IDAP REPORT

60 Shortland Avenue Strathfield
Property:	Lot: 202 DP: 15259 DA2020/209
Proposal:	Demolition of the existing structures and construction of a two (2) storey dwelling house, in-ground swimming pool and landscaping works.
Applicant:	Morrison Homes Pty Ltd
Owner:	S Tarvade and K Shrisat
Date of lodgement:	11 December 2020
Notification period:	13 to 29 January 2021
Submissions received:	One (1) submission
Assessment officer:	M Rivera
Estimated cost of works:	\$1,553,329.00
Zoning:	R2 – Low Density Residential – SLEP 2012
Heritage:	No
Flood affected:	No
Is a Clause 4.6 Variation Proposed:	No
RECOMMENDATION OF OFFICER:	APPROVAL

Figure 2. Site Analysis Plan

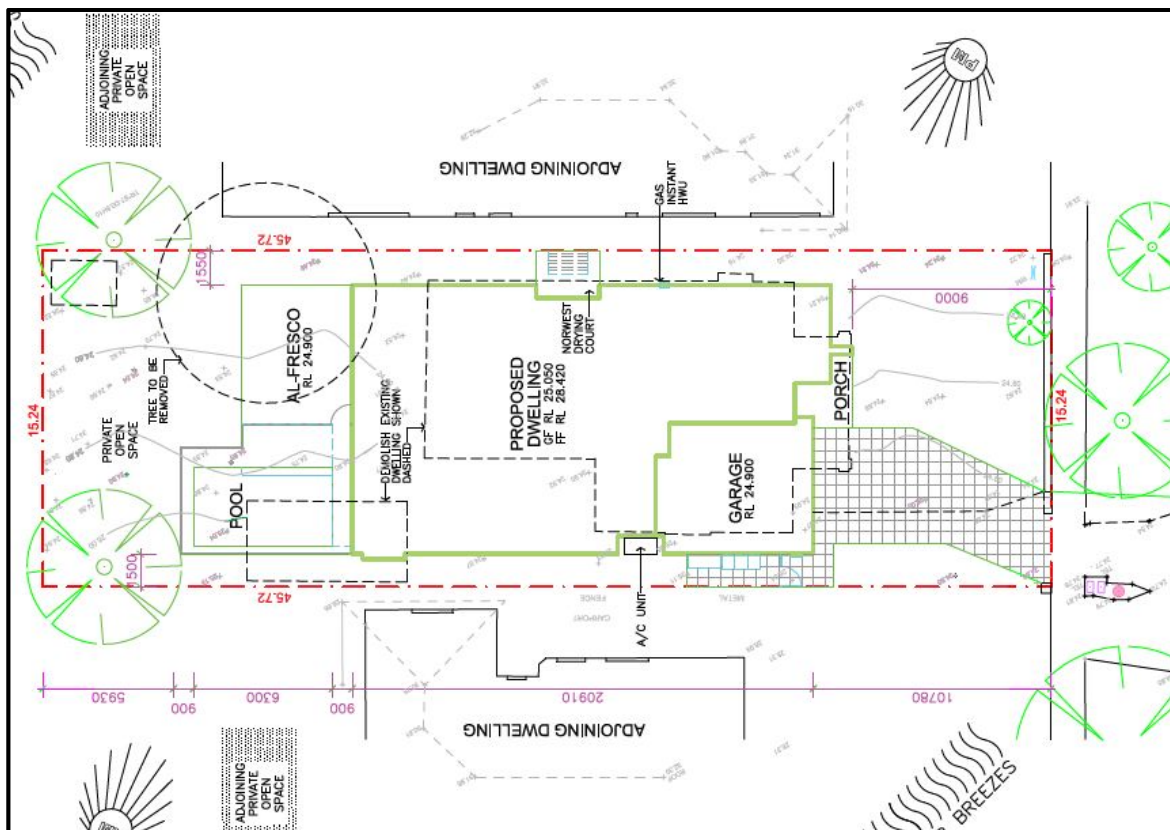
The applicant shall modify the internal driveway design in such a way that a vehicle leaving the property can be positioned fully perpendicular to the property boundary."

The Stormwater Management Plan will need to be amended to better protect the street tree and delete the below ground stormwater storage so that there is sufficient soil volume (48 cubic metres) and setbacks for the required tree planting."

Internal driveway	<p>The internal driveway must be modified to have additional paving on the eastern side and reduced paving on the western side as reflected in the stamped Site Plan.</p> <p>The removal of any proposed paving on the western side must be replaced with landscaped area (such as grassed lawn or garden beds with ground cover species) to compensate for the increased hardstand area.</p>
Landscape Plan	The Landscape Plan must be amended to reflect the above changes to the internal driveway.
Rear-facing balcony (first floor)	The balcony on the first floor, off the Family Room, must be deleted completely or reduced in size to have a maximum dimension of 2m (length) and 1m (width). The entire roof area above the alfresco (not including the balcony) must remain non-trafficable. These details are to be clearly shown and annotated on all plans and documentation submitted as part of the Construction Certificate.

Master Bedroom window (south-facing)	The south-facing window in the Master Bedroom must be modified to have a minimum sill height of 1.2m.
Stormwater Plan	The Stormwater Plan must be amended to re-locate the below-ground stormwater storage and any stormwater infrastructure so all existing street trees are retained and protected and that there is sufficient soil volume (48m ³) and setbacks for the required tree planting within the front setback.

Figure 4. First Floor Plan

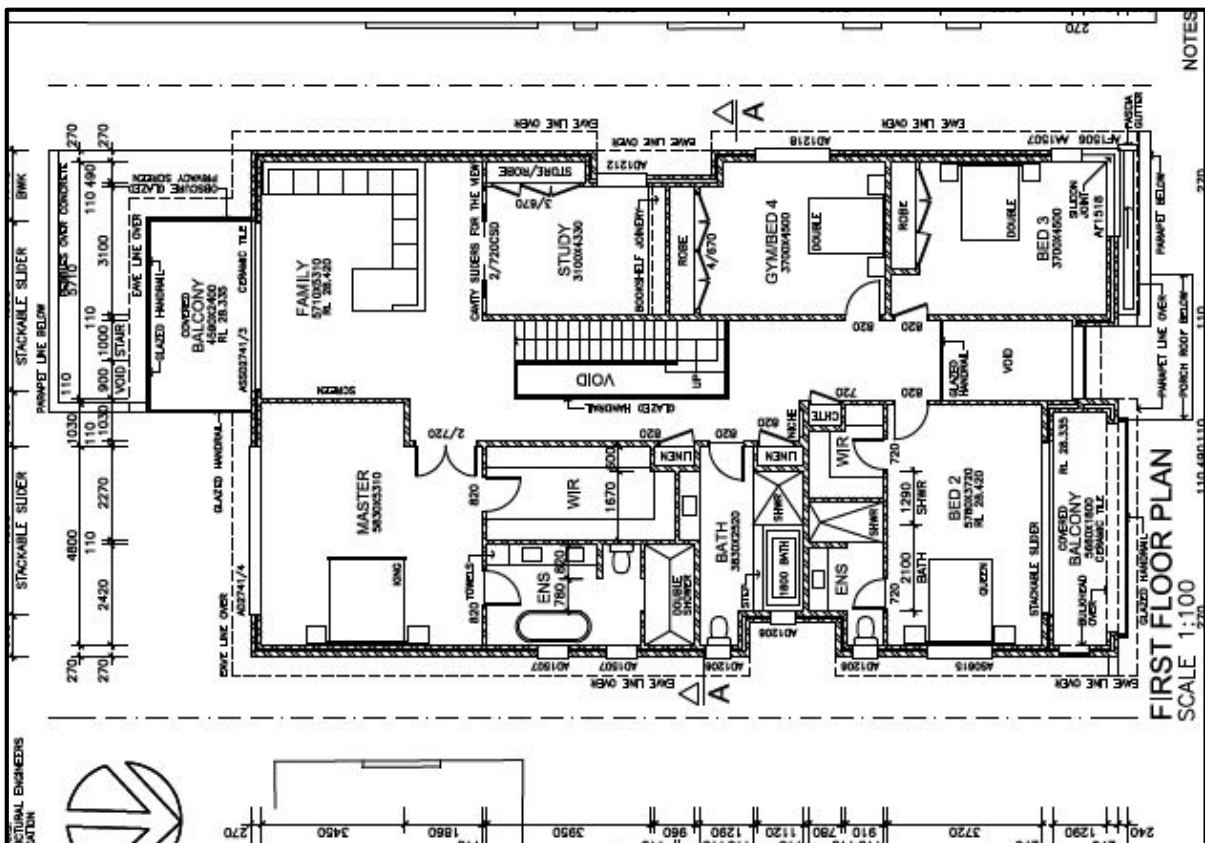
The windows on the first floor are mostly within bedrooms, bathrooms and study – which are considered low activity spaces. The rear-facing glazed sliding door in the family room is centralised and has a minimum side setback of 3.2m. The rear-facing balcony off the family room is also centralised and has an identical western side setback. A 1.7m high privacy screen is also proposed for the balcony. To minimise potential overlooking and amenity impacts a condition is recommended to either delete the balcony or reduce the size of the balcony to be maximum 2m in length by 1m width.

Privacy – rear-facing balcony	<p>In context of the site having an outlook on a public reserve, a rear-facing balcony that takes advantage of this outlook without compromising the privacy of neighbours is considered a reasonable and appropriate planning outcome. It is further noted that the balcony is over 7m away from the east-adjoining neighbour.</p> <p>The size of the balcony is considered excessive and a condition is recommended to either delete the balcony or</p>

Issue / Concern	Response
	reduce its dimensions to have a maximum length of 2m and maximum width of 1m.
Privacy – master bedroom	A condition will be imposed to modify the slider doors to be windows with a minimum sill height of 1.2m to minimise privacy impacts.
Solar access	The orientation of the site, the location and orientation of the proposal and the proposed setbacks and building height – all ensure that the proposal is able to comply with the relevant requirements associated with solar access and overshadowing impacts under the SCDCP 2005.
Rear setbacks	The proposed swimming pool complies with the minimum setbacks under the SCDCP 2005. A condition can be imposed to ensure that deep soil landscaped areas comprising shrubs/screen planting are established along the eastern extent of the pool.
Air conditioning system	A condition can be imposed to ensure that an acoustic engineer can certify the design and construction of an air conditioner to not produce a sound level exceeding 5 db(A) above the ambient background level of the closest neighbouring boundary prior to the issuing of an Occupation Certificate.
